RENESAS TECHNICAL UPDATE

Product Category	MPU&MCU		Document No.	TN-H8*-A334A/E	Rev.	1.00
Title	H8/38099 Group About the change of the pin assignment figure		Information Category	Technical Notification		
Applicable Product	H8/38099 Group	Lot No.	Reference Document	H8/38099 Hardware Manual (REJ09B0309-0100 Rev.1.00)		
		All

We would like to inform you about the change of the pin assignment figure for H8/38099 Group.

Figure 1. 2 Pin Assignment of H8/38099 Group (PLQ P0100KB -A)

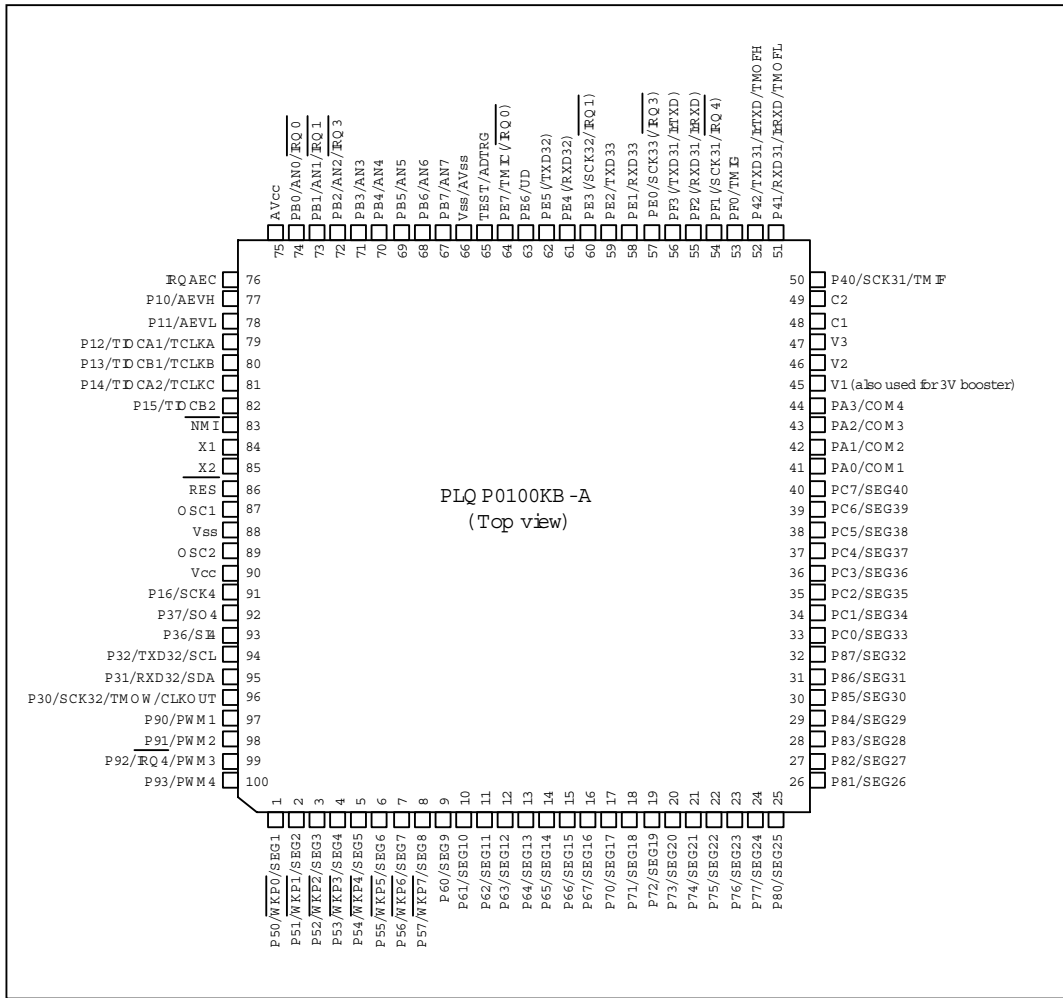
Before change

Figure 1. 2 Pin Assignment of H8/38099 Group (PLQ P0100KB -A)

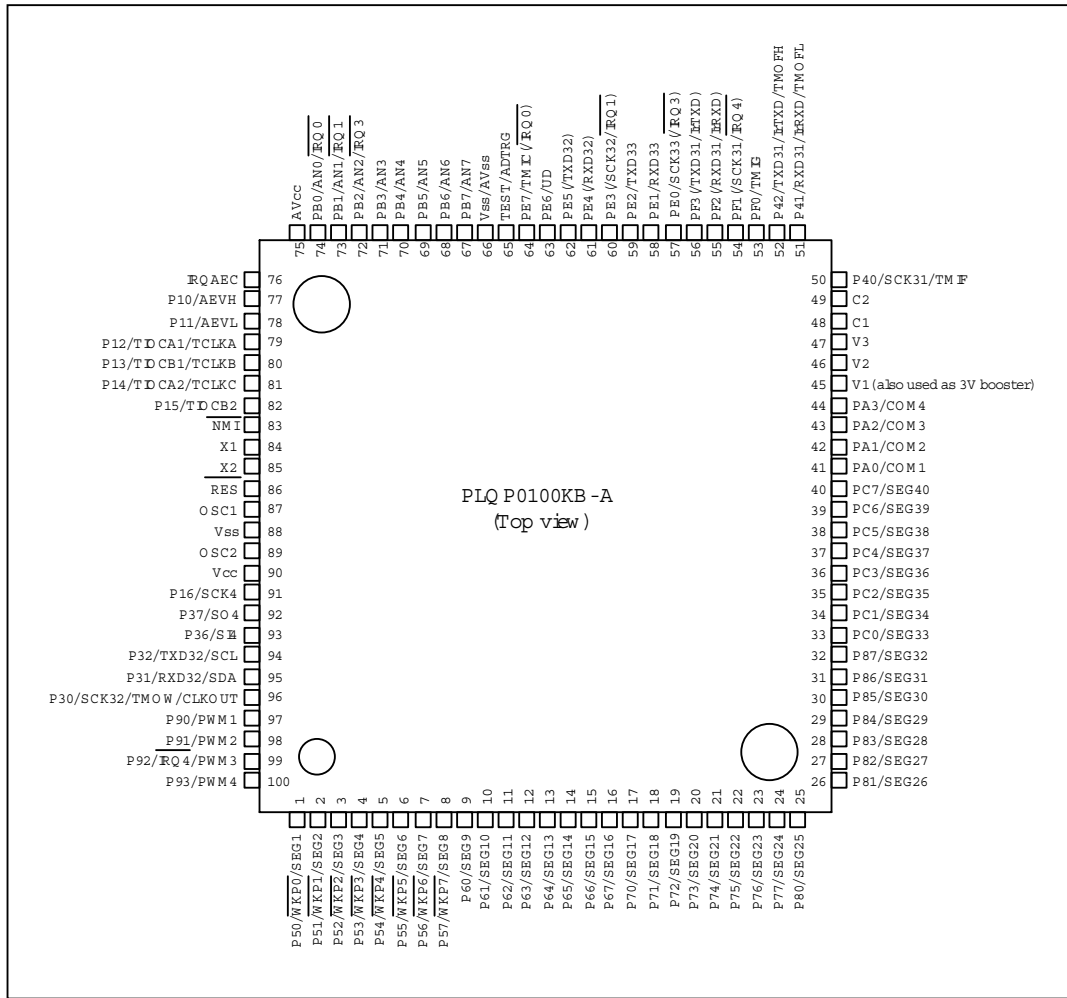
After change
